STATE OF DELAWARE
EXECUTIVE DEPARTMENT
OFFICE OF STATE PLANNING COORDINATION

RE: PLUS review – 2012-11-01; Overbrook Town Center

Thank you for meeting with State agency planners on November 28, 2012 to discuss the proposed plans for the Overbrook Town Center to be located on the Southeast corner of Route 1 and Cave Neck Road in Sussex County.

Figure 1: Map showing proximity of project to the Great Marsh

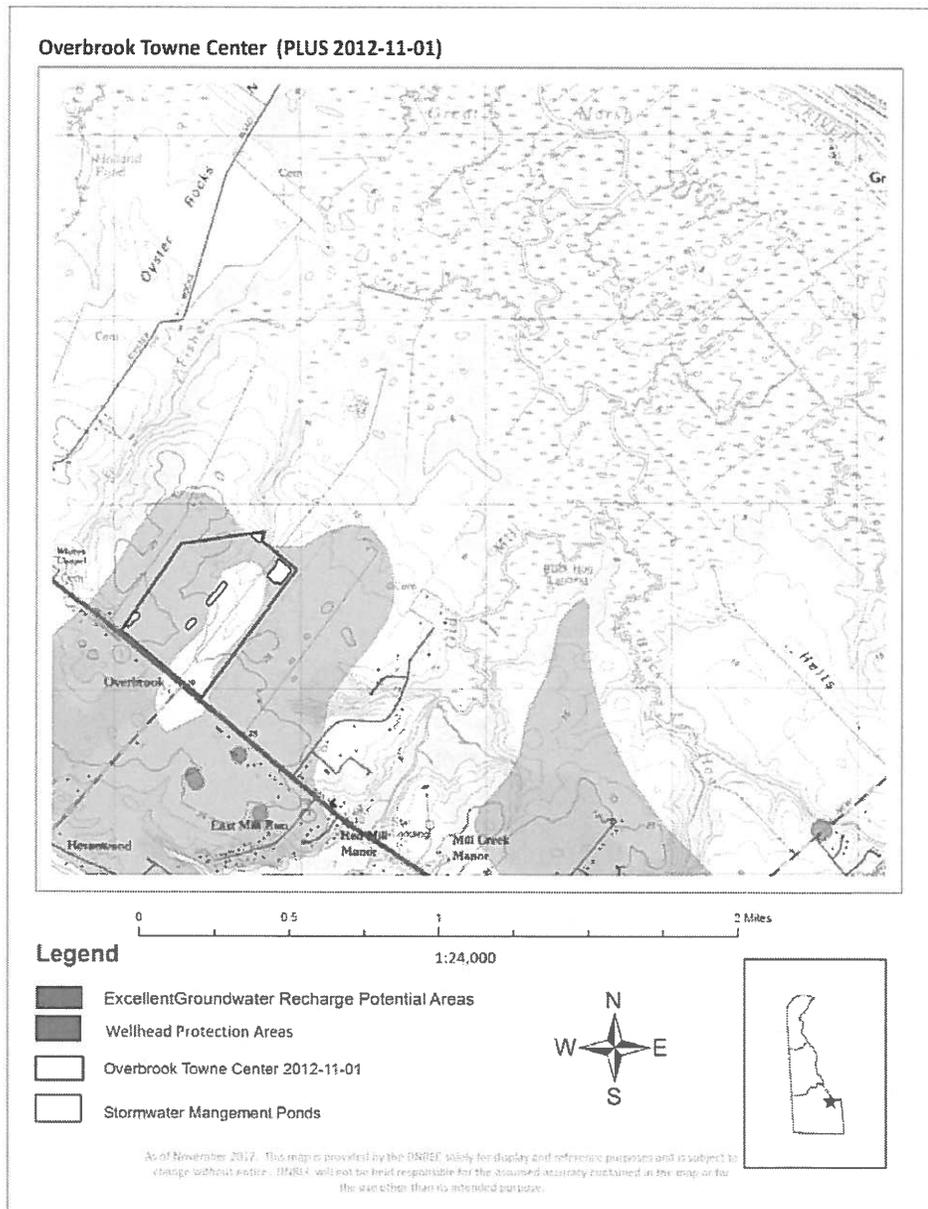
- The DNREC Water Supply Section, Ground-Water Protection Branch (GPB) has determined that a significant portion falls within an excellent ground-water recharge potential area for the Sussex County. The site plan indicates that stormwater management ponds and a significant amount of impervious cover fall within the area of excellent groundwater recharge. This project falls within Strategies for State Policies and Spending (SSPS) Investment Level 3 area (Figure 1).

- The site plan shows stormwater management ponds in the area of excellent groundwater recharge potential (Figure 1). The construction phase of storm water management ponds requires excavation, hauling, and grading. The heavy equipment used in this phase has the capacity to compact and degrade the structure of the strata that defines the area as an excellent ground-water recharge area (Schueler, 2000). Changes to the structural soil properties may cause significant reduction in recharge capacity. Installing storm-water management ponds in excellent ground-water recharge areas has the potential to contaminate the ground water beneath it and infiltrate into the aquifer.

From a hydrogeologic perspective, this excellent ground-water recharge potential area is located in a SSPS Level 3 area where environmental constraints should be considered. This recharge area is located between Fisher Creek and Old Mill Creek. These Creeks flow into the Great Marsh. Disrupting the infiltration process of this recharge area has the potential to introduce greater volumes of runoff to the Great Marsh and reduce the volume of water recharged to the unconfined aquifer (Figure 2).
